AUGMENTATION

BUSHFIRE MITIGATION

PAL RRP BUS 3.3.05 – PUBLIC
2026–31 REVISED PROPOSAL

This business case addendum sets out our response to the AER's draft decision on our bushfire mitigation program and describes the further work we have undertaken since our original proposal.

FIGURE 1 MULTI-PERIOD ANNUAL RELIABILITY BENEFIT (MWH)

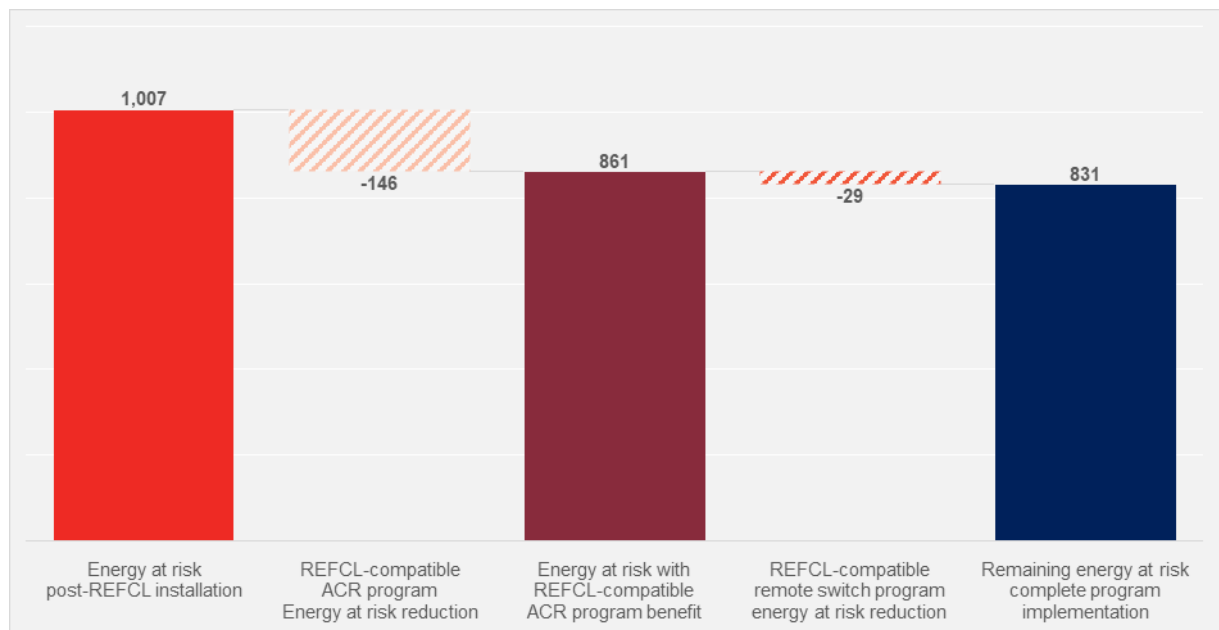
In its draft decision, the AER found that we had not accounted for the benefits arising from the roll-out of RECL-compatible ACRs under our mitigating REFCL reliability impacts program, underway in the current 2021–26 regulatory period.

We accept that we have not considered the expected improvement in reliability across the REFCL network resulting from the roll out of REFCL-compatible ACRs. We consider these benefits below and in our revised risk model.⁶

We forecast the roll out of REFCL-compatible ACRs would result in a 211 MWh reduction in energy at risk across our REFCL-protected network when we proposed the program in 2021.⁷ The rollout of REFCL-compatible ACRs began in FY24, whereas base case energy at risk in our proposal is captured as a five-year average ending in FY23. As a result, our revised proposal considers the full scope of energy at risk reduction from our REFCL-compatible ACR program.

Our proposal restores earth fault current detection capability to remote-controlled switches across 65 of the 88 feeders targeted in our REFCL-compatible ACR program. To calculate the benefit of our REFCL-compatible ACR program, we:

- allocated energy at risk reduction across the feeders targeted for REFCL-compatible ACRs, weighted by the number of ACRs on a feeder
- excluded energy at risk from the feeders on which remote-controlled switches do not operate
- subtracted remaining energy at risk from the base case of our revised Maintaining REFCL reliability proposal.⁸

Figure 1 captures the multi-period reduction in energy at risk from our REFCL-compatible ACR program and our proposed REFCL-compatible remote switch program.
